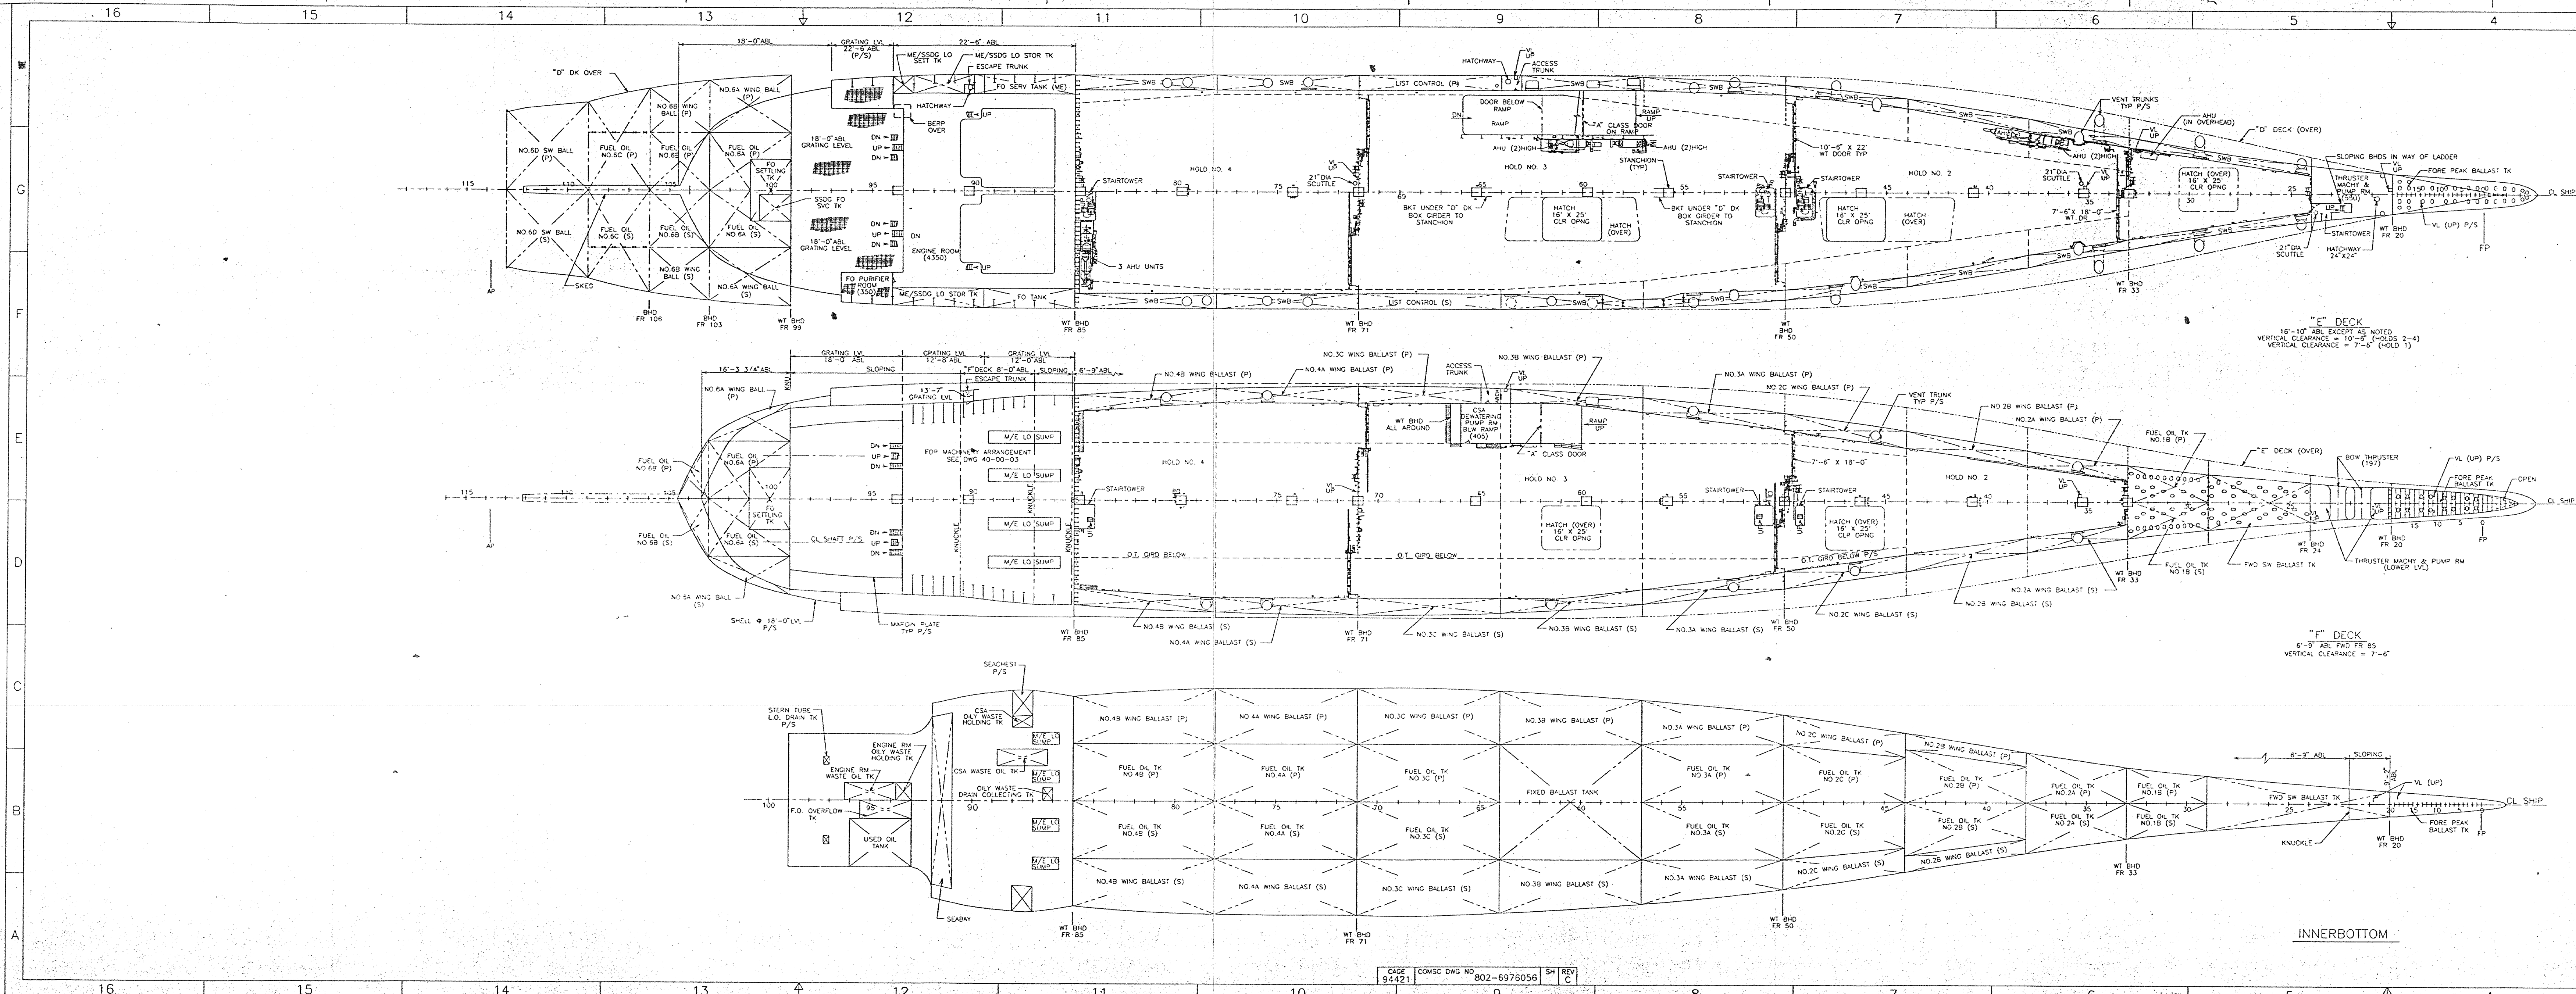
CHANGED LOCATIONS OF AT DOORS ON RAMPS TO SUIT STRUCTURAL DEVELOPMENT.

REPL ALL STIFFENERS ON BHD 33 TO FWD SIDE TO SUIT STRUCTURAL DEVELOPMENT.

GENERAL REVISED DRAWING TO UPDATE WITH C & A DRAWINGS.

VERIFIED LOCATION AND REVISED CALLOUT OF DOOR INDICATED ON "E" & "F" DECK RAMPS TO READ "FIRE DOOR" TO CORRECT.

UPDATED RAMP DECK CUTS TO SUIT STRUCTURAL DEV.

ADDED MECH PROTECTION TO VENTS P/2 AT FR 35.5.

UPDATED VENTILATION ARRIST TO SUIT STRUCTURAL DEV.

VERTICAL LADDERS IN ALL STARTIOWERS DELETED TO SUIT FWR-87.

RECLASSIFIED RAMP DOORS TO SUIT DEVELOPMENT.

INDICATED UNDER DP BKTS ON STANCHIONS AT FR 55 & 65 ON "E" DK ARRANGEMENT.

REVISED CONFIGURATION OF W/E LO PUMPS TO SUIT STRUCTURAL DEVELOPMENT.

"F" DK REVISED DRATING LEVEL AB. CALLOUT BTWN FR 85-94 TO CORRECT. INVERTED REVISED LOCATION OF Q/W WASTE LK TO CORRECT. "E" & "F" DKS ADDED LABELING TO NEW TRUNKS TO SUIT.

LONG BHD AFT FR 89 (2/5) CHANGED TO 26-0" OFF CL IN LIEU OF 30-0" OFF CL TO SUIT.

DELETED VENT FRANKS @ BHD 20.

DELETED VENT FRANKS @ FR 30.

DELETED STARTERWORMS & VENT TRUNKS @ FR 50.

DELETED STARTERWORMS & VENT TRUNKS @ FR 71.

DELETED VENT TRUNKS @ FR 85.

DELETED ESCAPE TRUNK @ FR 50 FROM "E" & "F" DECKS.

DELETED ESCAPE TRUNK FROM FR 85 TO FR 71.

DELETED ESCAPE TRUNK @ FR 85.

DELETED COLUMN @ FR 62 STBD FROM "E" & "F" DECKS.
